Re: Lake-Leonard-Grandview Intersection Review

Progressive AE has completed the traffic and safety review of the existing Lake Avenue/Leonard Road/Grandview Avenue intersection located in the southeastern portion of the Village of Spring Lake (Village). Our comments and recommendations stemming from our analyses are summarized in the following sections.

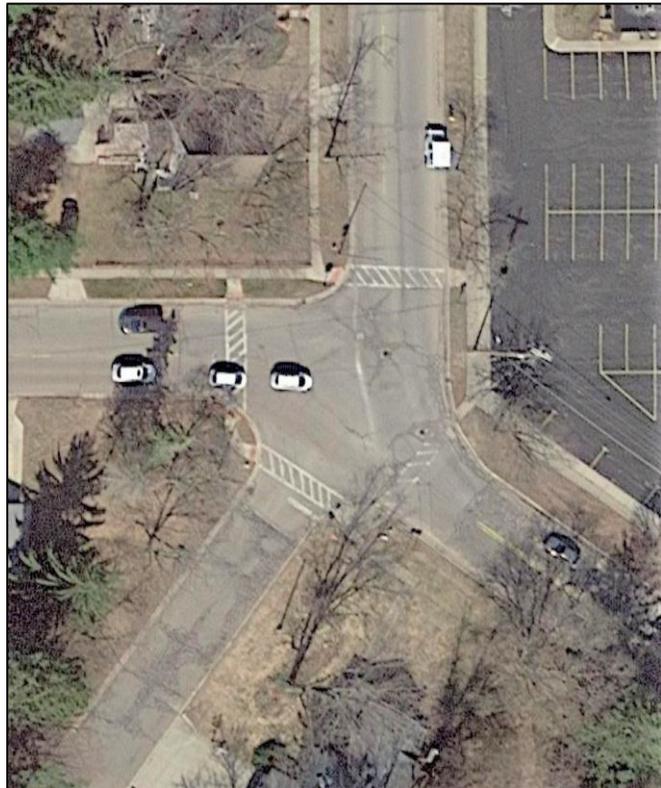
Eight (8) crashes over a 5+ period is considered low, even for an intersection that experiences relatively low traffic volumes. The crash history also indicates the Lake Avenue-to-Leonard Road curve is the primary geometric issue as opposed to the overall odd shape of the intersection, although even then it is mainly just during icy conditions.

1. Replace the faded "When Turning Left" sign on the Leonard Road approach to the intersection.
2. Place lane lines to/from Leonard Road to/from Lake Avenue that flatten out that curve slightly; this will reduce crash potent and provide a better sightline for northwest-bound Leonard Road drivers to see pedestrians crossing Lake Avenue.

3. Consider eliminating the crosswalk across Grandview Avenue (and the south leg of Lake Avenue). The current location creates a situation where pedestrians cross between queued vehicles, an inherently unsafe condition. Or because the completed counts indicated no pedestrians used that crosswalk during any of the six (6) hours that were recorded.

4. Continue to update/freshen the crosswalk markings on the north (Lake Avenue) side of the intersection.
5. Since northbound Lake Avenue has a 25 mile per hour (mph) speed limit anyway, consider changing the northwest-bound Leonard Road speed from 30 mph to 25 mph with a sign located approximately 250-feet from the intersection.
